As you know I am the owner of the lot immediately to the south of the proposed development PLN50589. As you know are aware the easement AFB 200103260191 refers to an easement on Lot B and adjacent to my property immediately to the south.

I am writing concerning the SEPA application. I only received the notice very recent and the given the complexity of the changes as they relate to the development adjacent to and lying immediately to the north of my property, my response arrives towards the end of the response period.

My current concerns relate to both inaccuracies of the PDF's (specifically the drawings) for the SEPA (4/11/2018) and less than clear wording in the "Open space management plan". I believe that these inaccuracies and lack of clarity could significantly complicate the overall project.

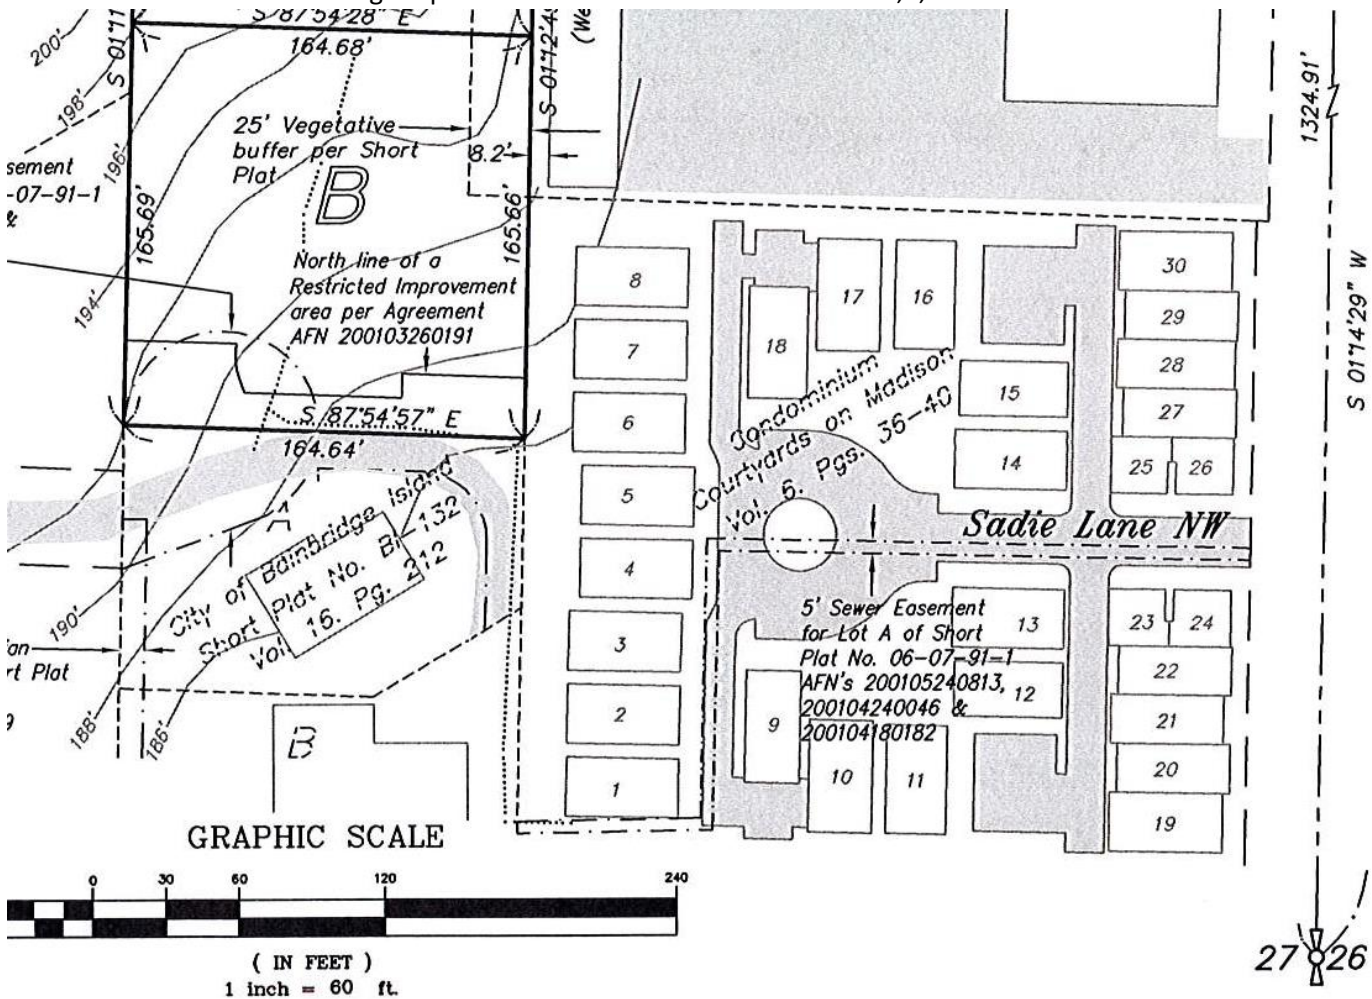
1. Specifically both drawings below shows a setback of 18.56 feet between Lot 8 and the southern boundary line of lot B. However, AFB 200103260191 specifies a setback of 35 feet. My understanding from the builder is that the plans have changed and that the drawing on the SEPA document are likely in error and reflect an older document. Be that as it may, the SEPA plan as it stands is likely in error and I feel the SEPA plan should be corrected specific parties involved have ample time to review it. Once again, I point out that we were informed by the city that we were one of the properties did not receive the initial notification of the SEPA application.

2. Another concern is that "Open Space" is shown immediately to the south of Lot 8. Again, there is potential conflict with AFB200103260191 wherein the plan shows that shown open space lies within the easement. The open space management plan contains the wording *"A low impact fence eg split rail delineating the boundary of the open space area shall be maintained along the boundary between the open space and the lot or right of way."* I have two problems with the above conflict.

- I find the language of the open space management plan vague wherein the wording "lot or right of way" lacks clarity. Furthermore, I believe that the specific drawing (below) detailing the open space contains substantial error in the placement of Lot 8 (off by 17 feet to the south) and therefore making me lose confidence in the intended placement of the "open space". In other words, will the "open space" lie within the easement or will it be adjacent to the north border of the easement or both? Furthermore, because of shading issues it is not clear if the open space will stop at the "utilities easement" or could it possibly lie over the utilities easement.

- In either case above (ie. open space either within the easement or immediately north of the easement) *the easement AFB 200103260191 absolutely specifies the details of a solid fence (ie. Not split rail) In fact the fence remains in place and is located as shown (with a minor error) on the bottom drawing.* And I beg you to recall the purpose of the easement was for the benefit of the property to the south as regards the view and placement of the open space.

Please refer to the two drawings copied below from "Revised Plat Sheets 4,5,6 and 7.PDF

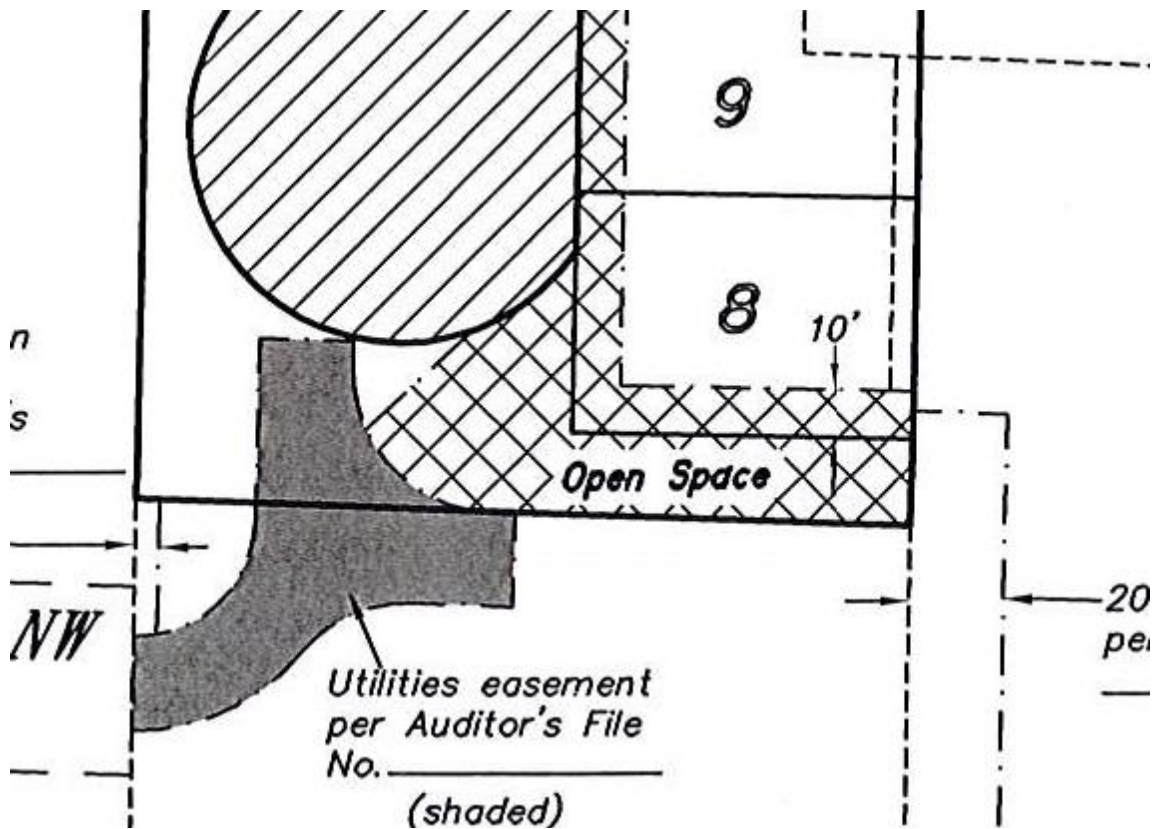
ABOVE ITEM is 4/22/1028 Revised Opens Space Management Plan 4-10-18.PDF The southern most aspect of this drawing outlines a "Restricted improvement area per agreement 920003260191

Furthermore The same document below shows the same land as "Opens Space" and does not show that it is in fact a "Restricted Improvement area per Agreement 920003260191"
